**TRANSMITTAL OF CHANGE PAGES TO THE CERTIFICATION DESIGN LETTER FOR
AREA 1, PHASE II CERTIFIED FOR REUSE AREAS, TRAP RANGE, SECTOR 2C, AND
SECTOR 3**

**CERTIFICATION DESIGN LETTER
FOR AREA 1, PHASE II,
CERTIFIED FOR REUSE AREAS,
TRAP RANGE, SECTOR 2C, AND SECTOR 3**

**20710-RP-0014
REVISION 0
PCN 2**

<u>Revision</u>	<u>Date</u>	<u>Description of Revision</u>
Rev. 0	2/11/00	Initial controlled issuance
PCN 1	4/7/00	Revised Figure 1-6 to remove shading within CU boundaries for S2-OS-01 and S2-LL-02
PCN 2	6/2/00	Revised the Executive Summary, Sections 1, 3, 4, and 5 and added Figures 1-7 and 1-8 to include additional information regarding recertification of portions of CUs A1P2-S1TR-01 and A1P2-S1TR-03 for lead and arsenic as a separate CU

FIGURE 1-7. SAMPLE LOCATIONS A1PII-SITR-12

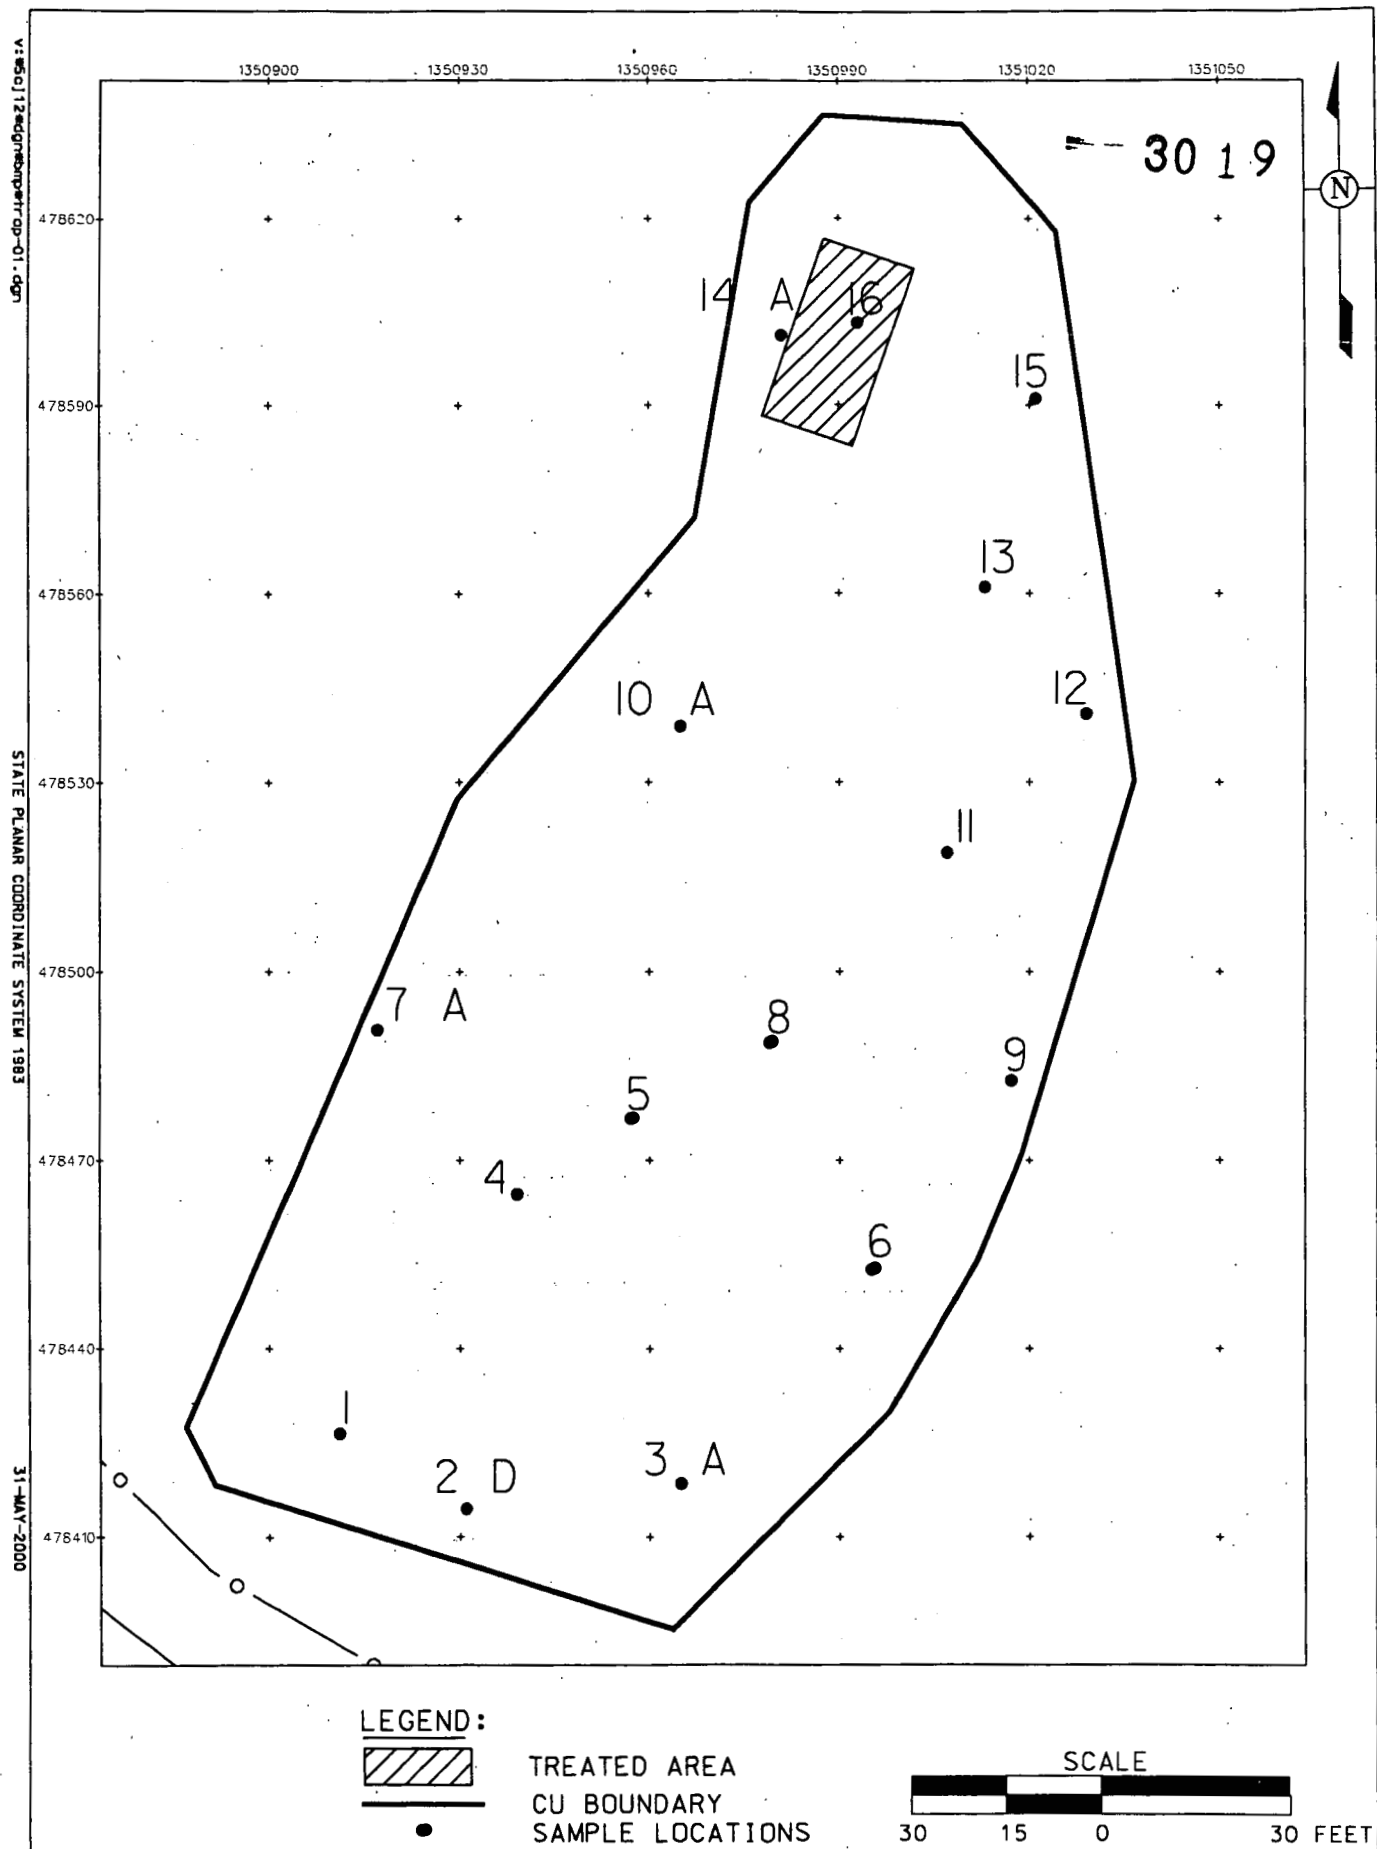
- A1P2-S1TR-12 - Remedial actions will be conducted on portions of two contiguous CUs which failed. CU A1P2-S1TR-01 failed because of a lead "hot spot" at location 09 and CU A1P2-S1TR-03 failed for arsenic concentrations. The "hot spot" will be treated by the stabilization contractor (an area measuring 30 feet by 15 feet by 3 inches deep) and upon passing TCLP criteria for lead, approximately 0.4 acres including the "hot spot" will be excavated to a depth of 6 inches. Sampling results from areas within the CUs, but outside this 0.4-acre excavation area pass certification criteria and are considered certified. The excavation area forms the boundary of this CU. The CU is shown on Figure 1.7.

- A1P2-S1TR-12 - This CU contains an excavation area of approximately 0.4 acres. Prior to excavation, a lead "hot spot" was treated by a stabilization contractor. One sample location was biased to fall within the 15-foot by 30-foot area where the treatment was conducted.

FIGURE 1-8. LOCATION OF CU A1P2-S1TR-12.

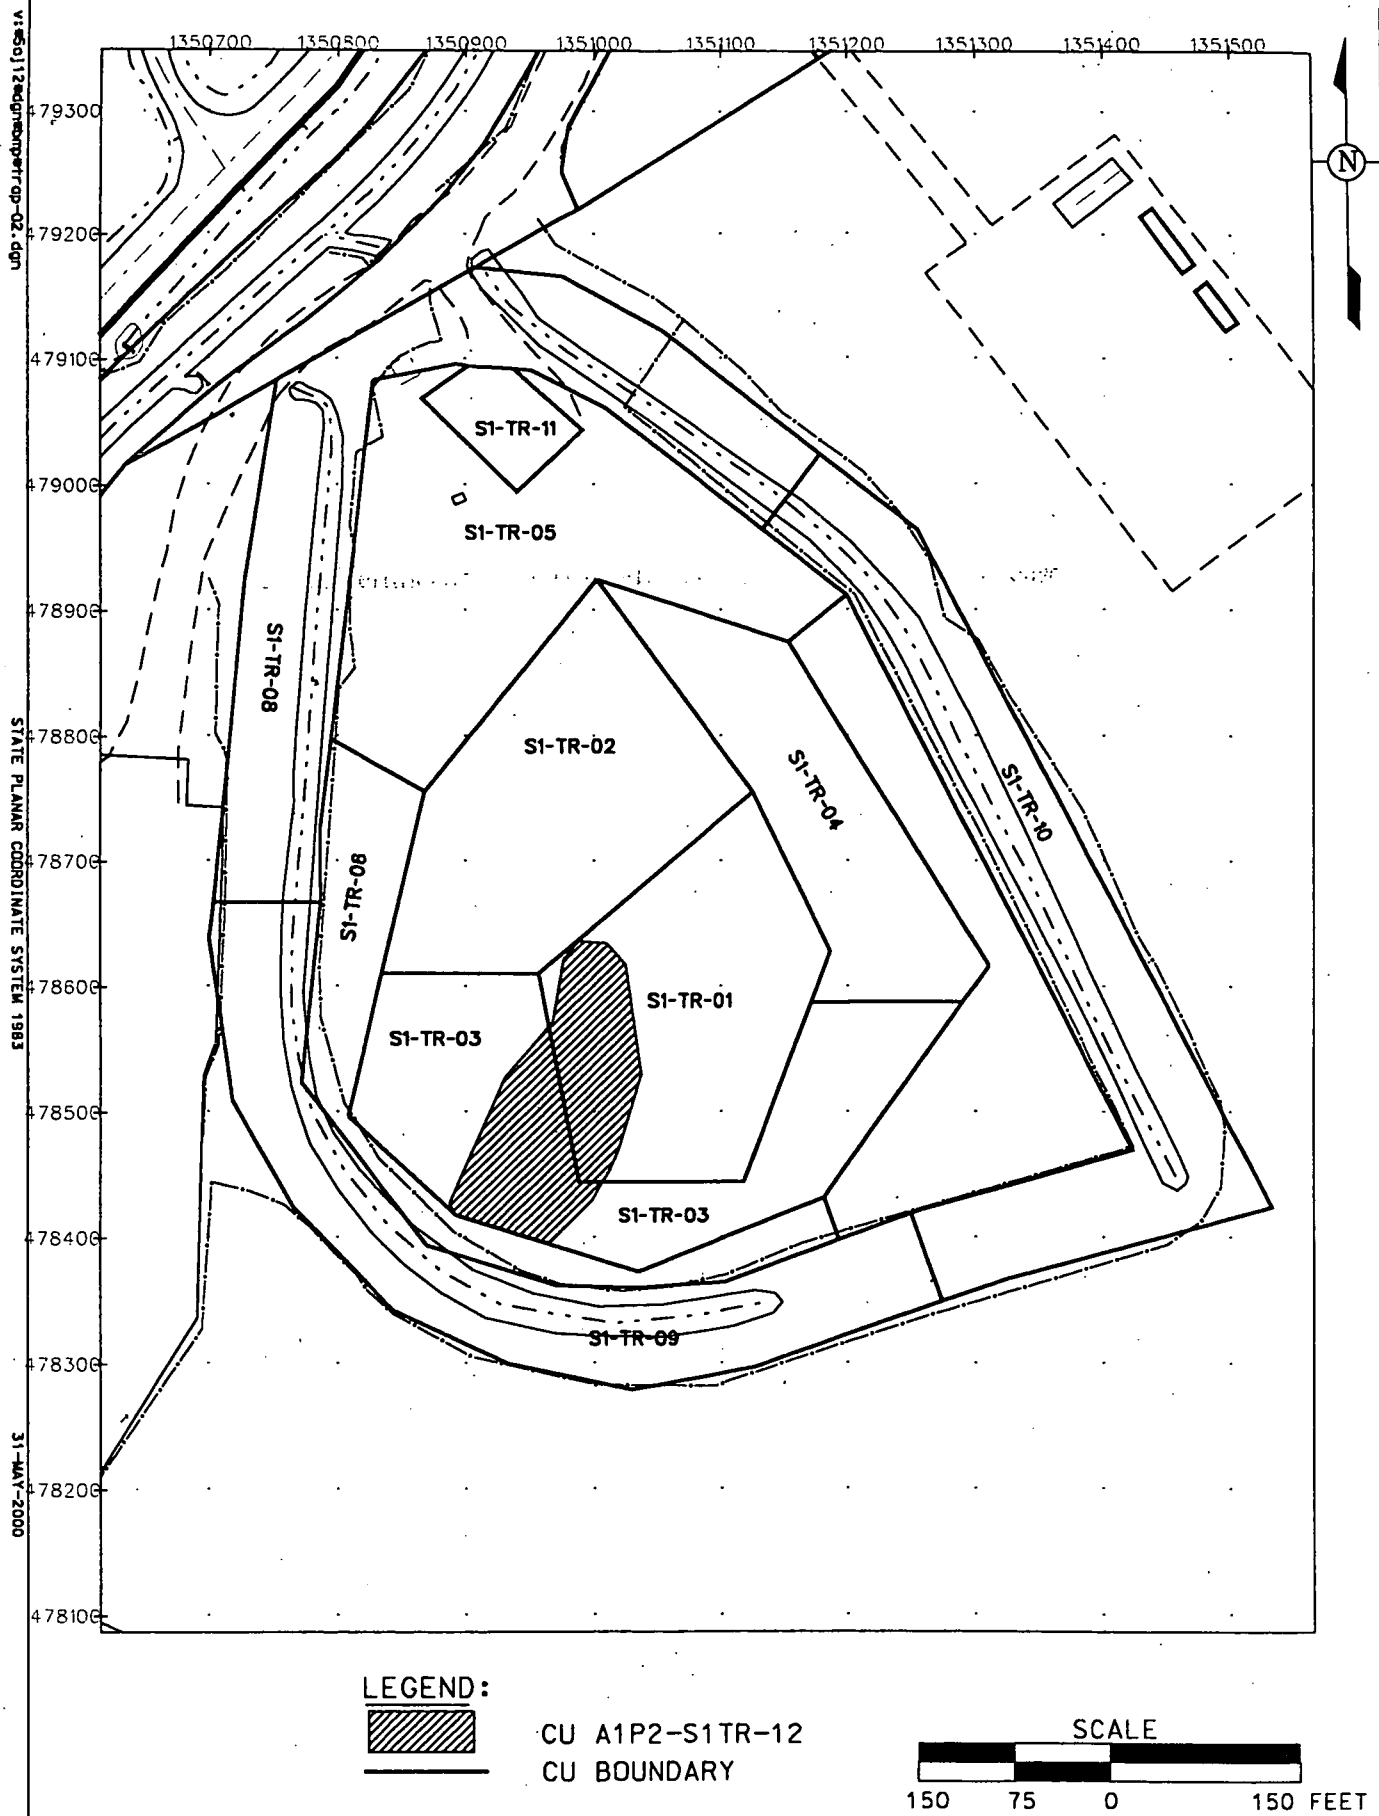
- The 0.4-acre area which includes portions of two CUs (A1P2-S1TR-01 and A1P2-S1TR-03) which failed for lead and arsenic. The excavation removed the top 6 inches of soil including the lead "hot spot" measuring 30 feet by 15 feet by 3 inches deep which was retreated by the stabilization contractor on May 22, 2000.
